Access Compliance Report

Public Rights-of-Way

(Curb Ramps)

Intersection ID: 3877	Main Street: DELLFIELD_WY	Cross Street: ROBIN_LN	Location: SW
ADA ID: 9DE883FB8217	Ramp Type: Perp	Initial Pass/Fail: Fail	Overall Compliance: No
Severity Score: 46.25			
Codes/Mitigation Info/Possible Solution		Field Measurements/Component Compliance

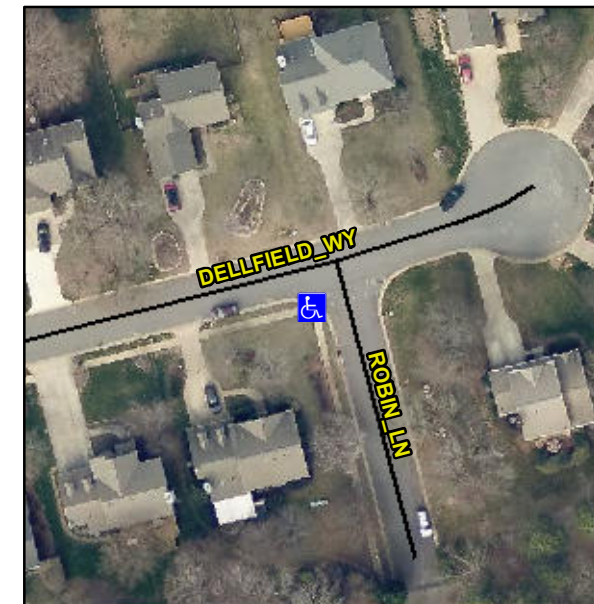
Not Found, R304.5.1, R304.2.2, R304.5.3

Compliance	Description	Data	Compliance	Description	Data
N/A	Ramp Length (in)	57.5	No	Ramp Slope (%)	10.7
No	Ramp Width (in)	37.0	No	Ramp XSlope (%)	10.2
N/A	Flare Type LT	N/A	N/A	Flare Type RT	N/A
N/A	Flare Slope LT (%)	N/A	N/A	Flare Slope RT (%)	N/A
N/A	Flare Traversable LT?	N/A	N/A	Flare Traversable RT?	N/A
N/A	Landing Length (in)	N/A	N/A	DWS Provided?	N/A
N/A	Landing Width (in)	N/A	N/A	DWS Contrast?	N/A
N/A	Landing Slope (%)	N/A	N/A	DWS Length (in)	N/A
N/A	Landing X Slope (%)	N/A	N/A	DWS Full Width?	N/A
N/A	Landing Curb? (Y/N)	N/A	N/A	DWS Offset (in)	N/A
N/A	Shared Landing?	N/A			
N/A	Gutter Ponding?	N/A	N/A	Gutter Slope (%)	N/A
N/A	Gutter Lip Ht (in)	N/A	N/A	Gutter X Slope (%)	N/A
N/A	Painted X Walk1?	No	N/A	Painted X Walk2?	N/A
	X Walk 1 Direction	To E		X Walk 2 Direction	N/A
N/A	X Walk 1 Width (in)	N/A	N/A	X Walk 2 Width (in)	N/A
	X Walk 1 Slope (%)	6.8		X Walk 2 Slope (%)	N/A
	X Walk 1 X Slope (%)	6.9		X Walk 2 X Slope (%)	N/A

Remove & Replace Entire Ramp.
